SECTION 009115
ADDENDUM NUMBER 5

- 1.1 DATE: January 12, 2022
- 1.2 PROJECT: Orangetown Town Hall Addition and Alterations
- 1.3 Owner: Town of Orangetown
- 1.4 Architect: Lothrop Associates LLP Architects

2 CROSS SECTION AT ATRIUM
1/8" = 1'-0"

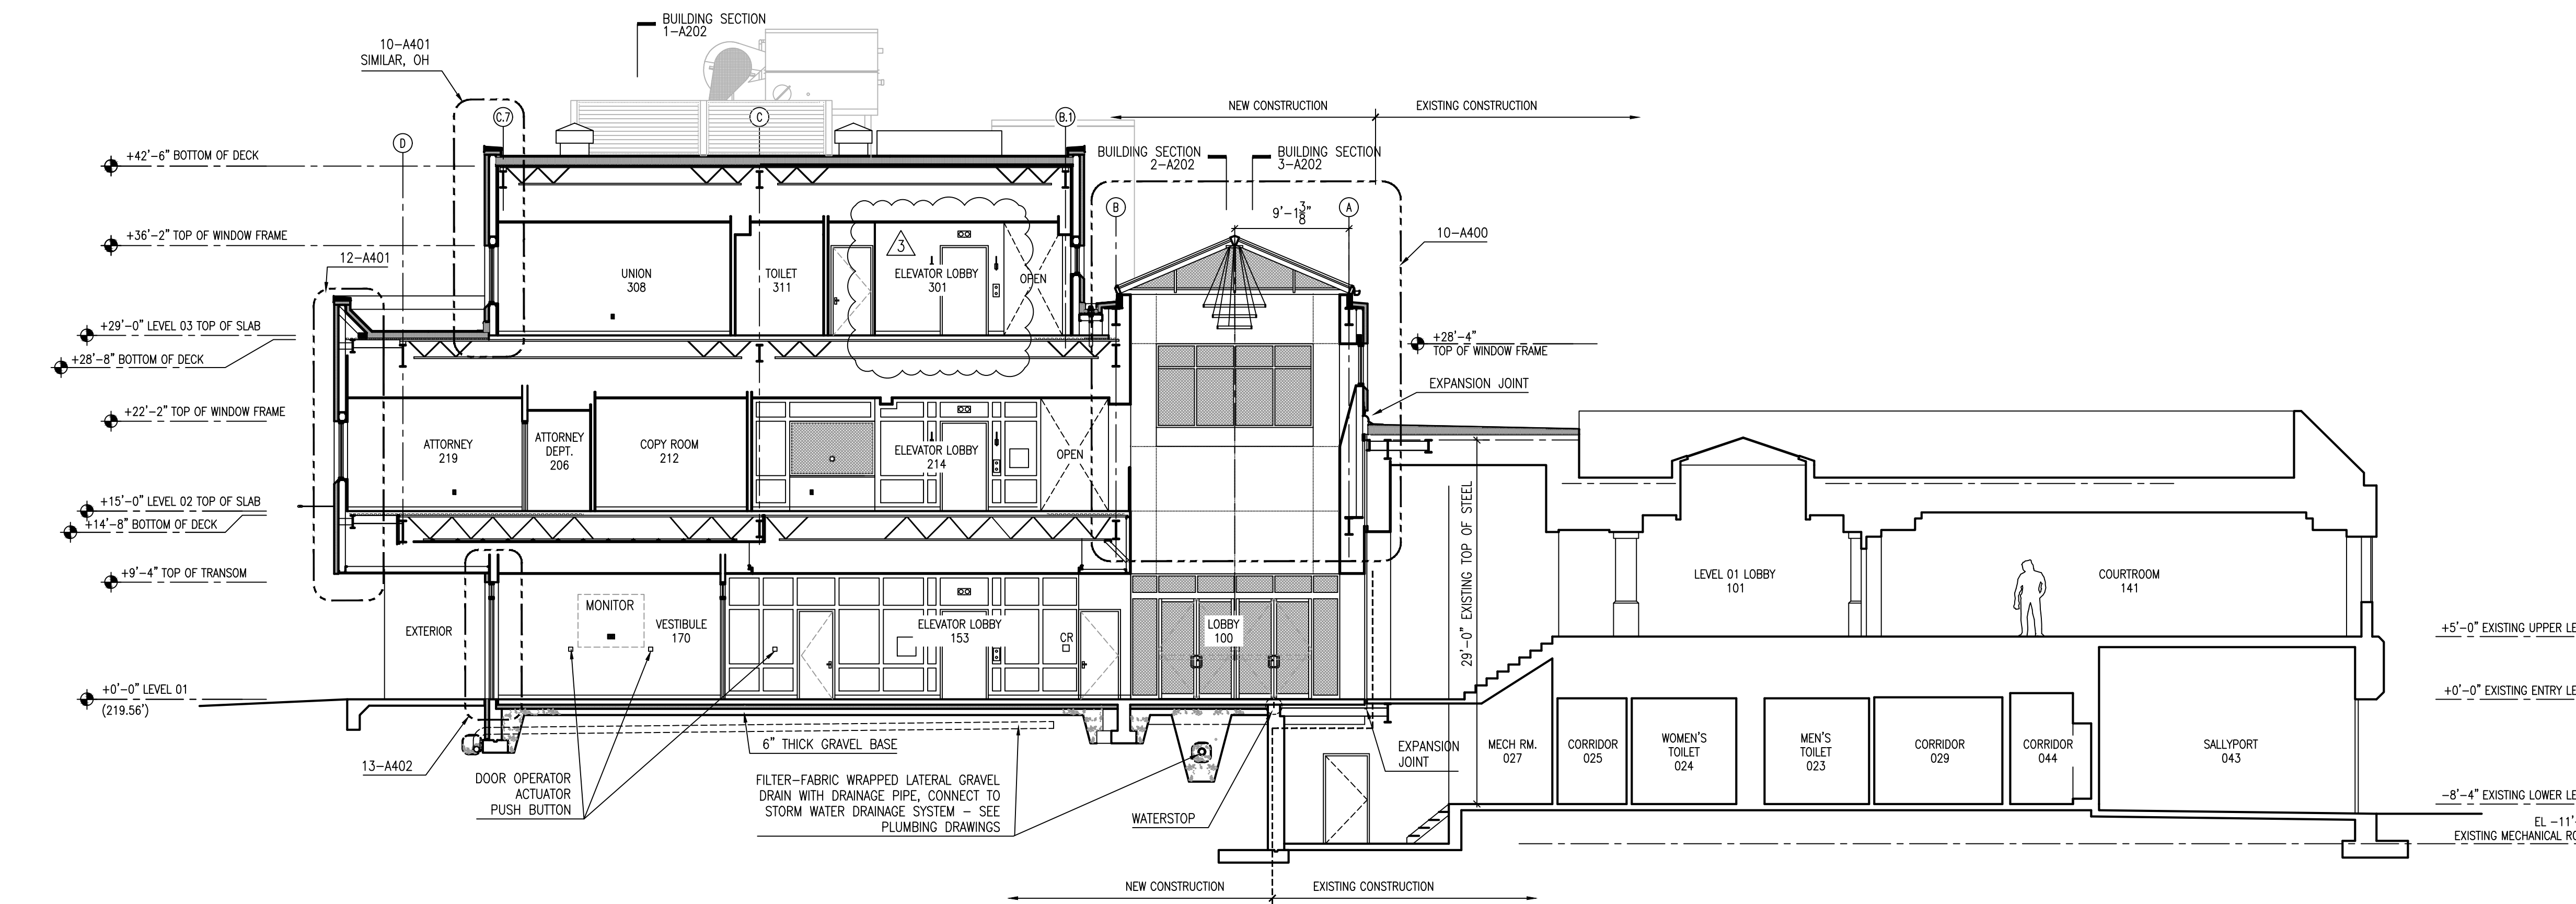
31. Floor Plan A113(B) does not indicate wood trim in the elevator lobby on the 3rd floor as it does on the 1st and 2nd floors. However, cross section 2/A-201 does indicate wood trim at the elevator. Unless clarified by Addendum, we assume Detail 2/A-201 is in error. (Architect's RFI #1G.22)

- a. **Drawing 2/A-201 is shown incorrectly. There is no wood trim in the elevator lobby on the 3rd floor.**

- A. **Remove and replace Drawing A201 with new drawing A201, attached to this Addendum.**

E-001

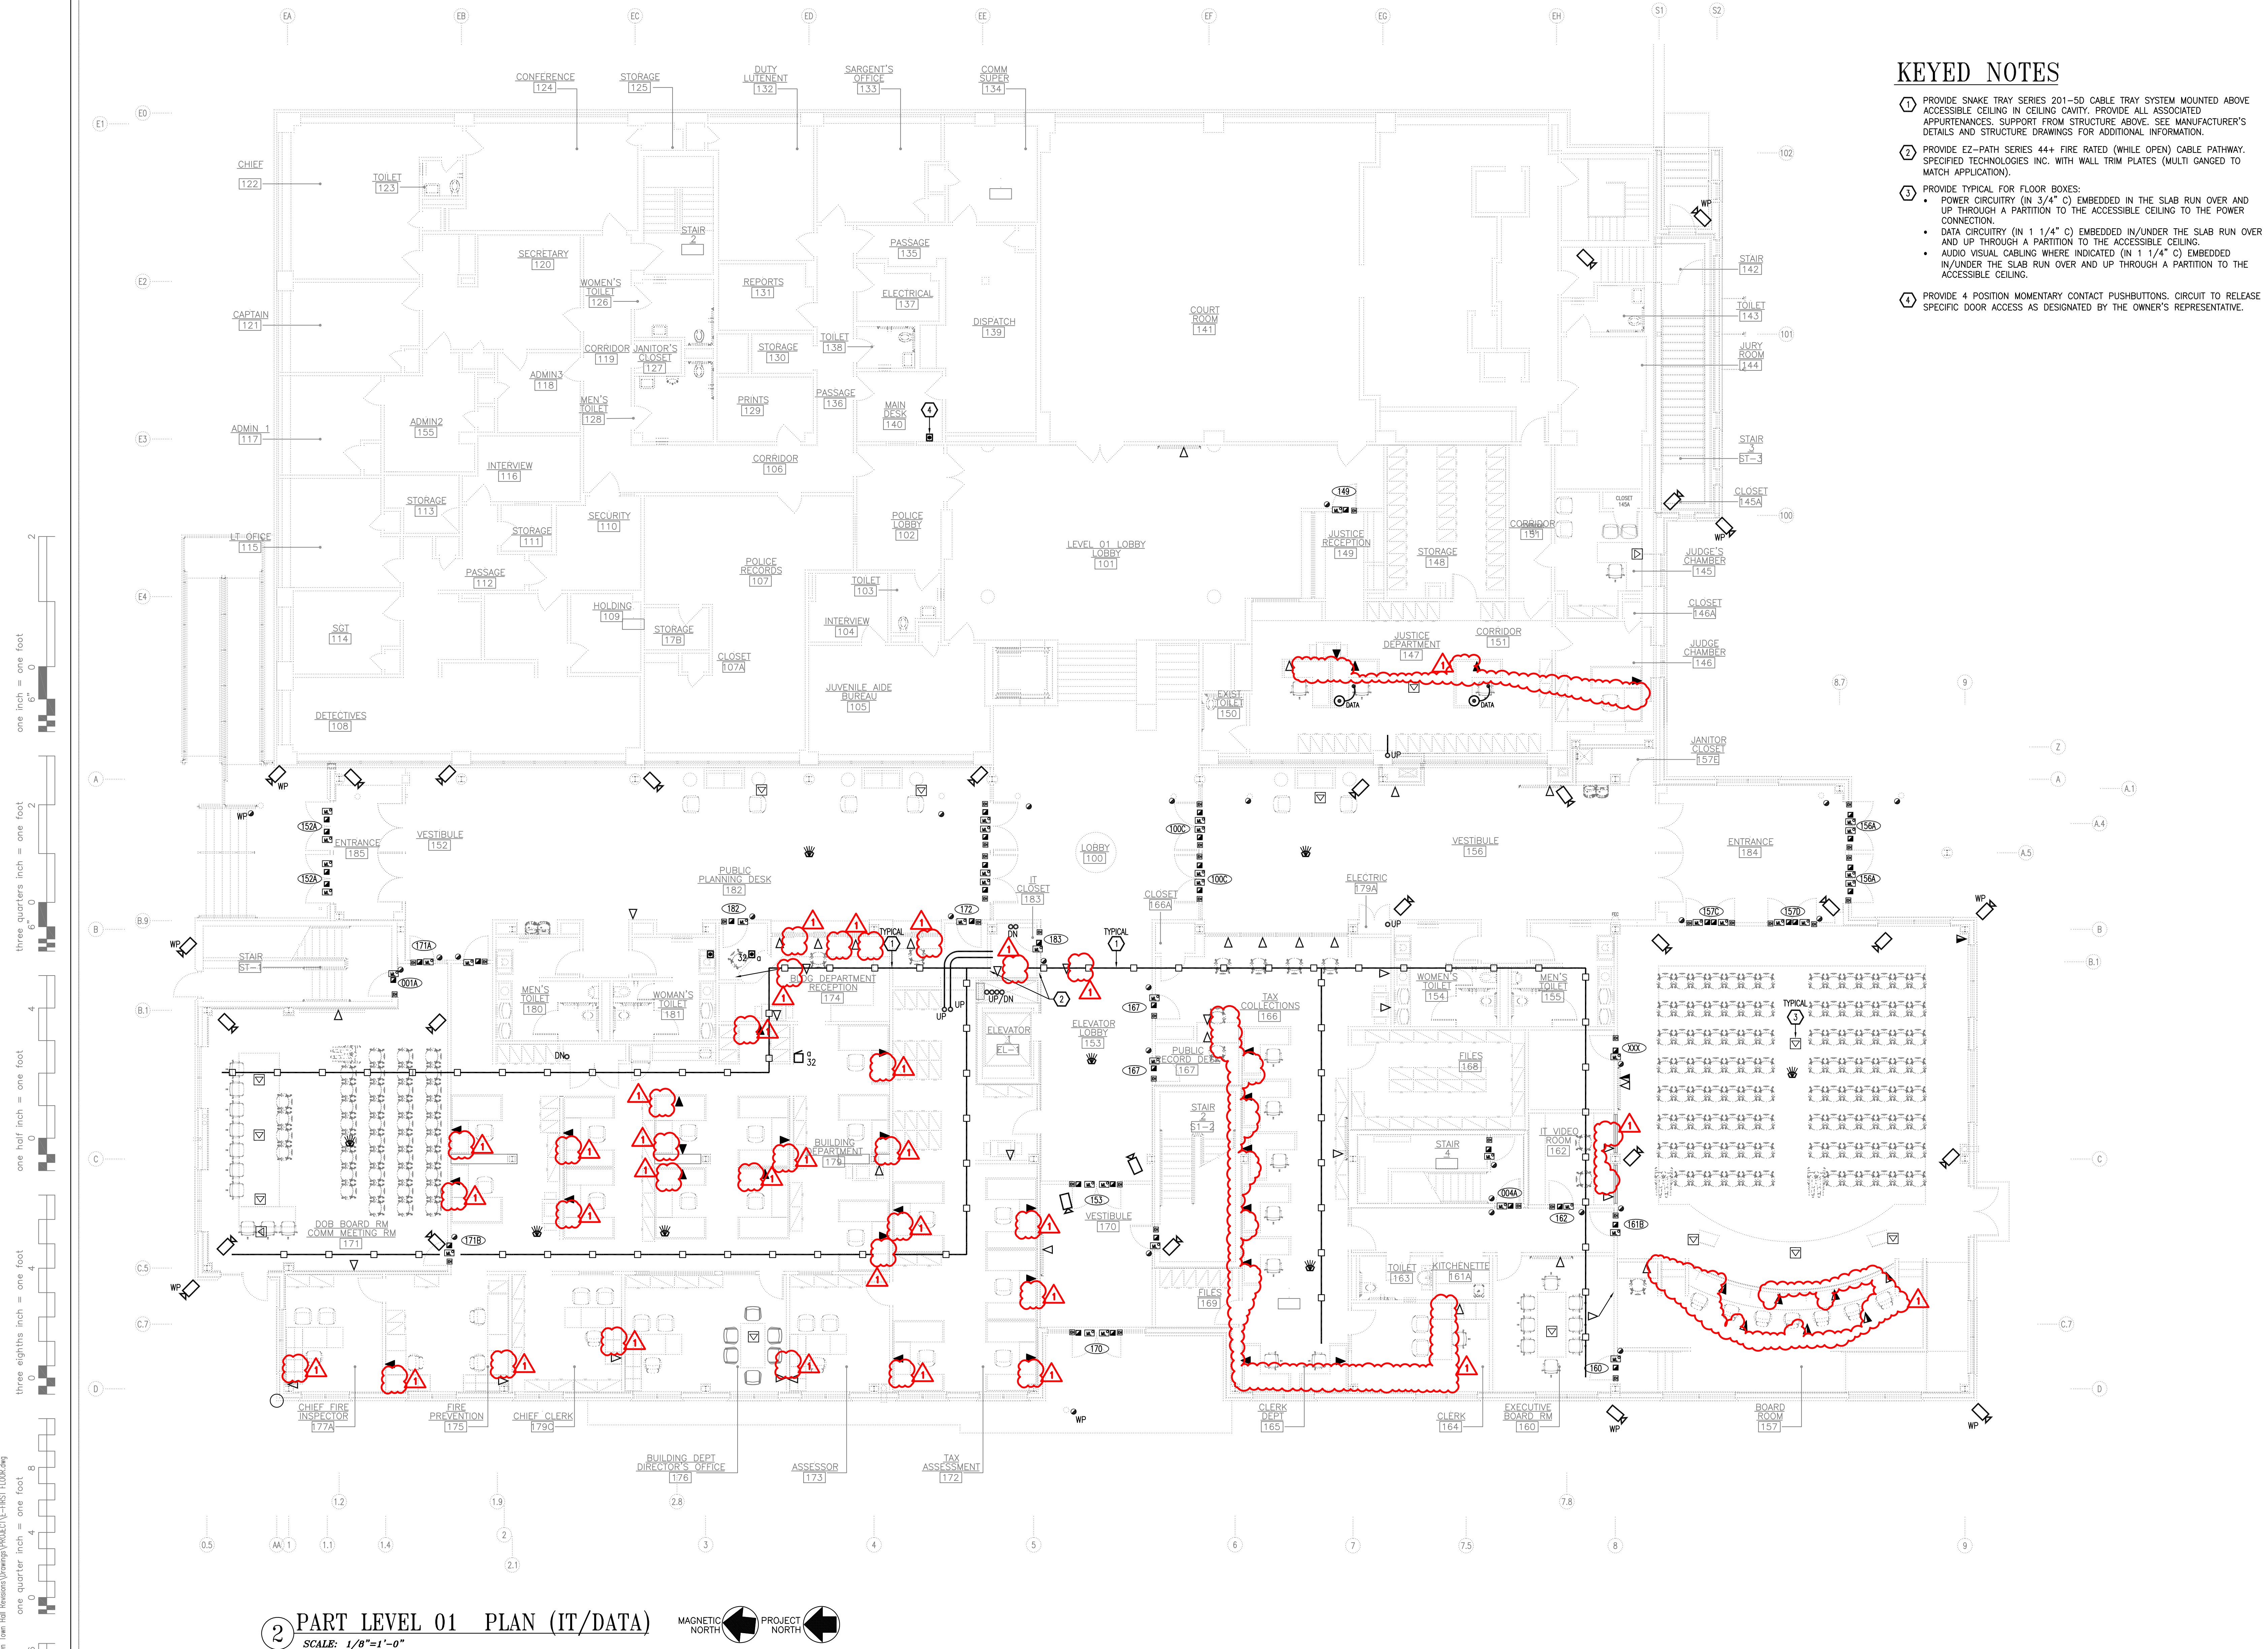
10. Please clarify the symbology identified on Drawing E-001. The open triangle symbol calls for 2 tel. and 2 data cables. The shaded triangle calls for the same except extend into modular furniture. The majority of locations show one open triangle and two shaded triangles. I'm not sure how to interpret this. Please advise. (Architect's RFI #4E.06)

- a. **See revised drawings E-001 Issue 2, E-208 Issue 2, E-213 Issue 2 and E-218 Issue 2.**
11. Drawing E-208 shows an open triangle and a split shaded triangle for Board Room 157. How many cables are required by these? (Architect's RFI #4E.06)

- A. **Remove and replace Drawing E-001, Issue 1 with new drawing E-001, Issue 2 attached to this Addendum.**
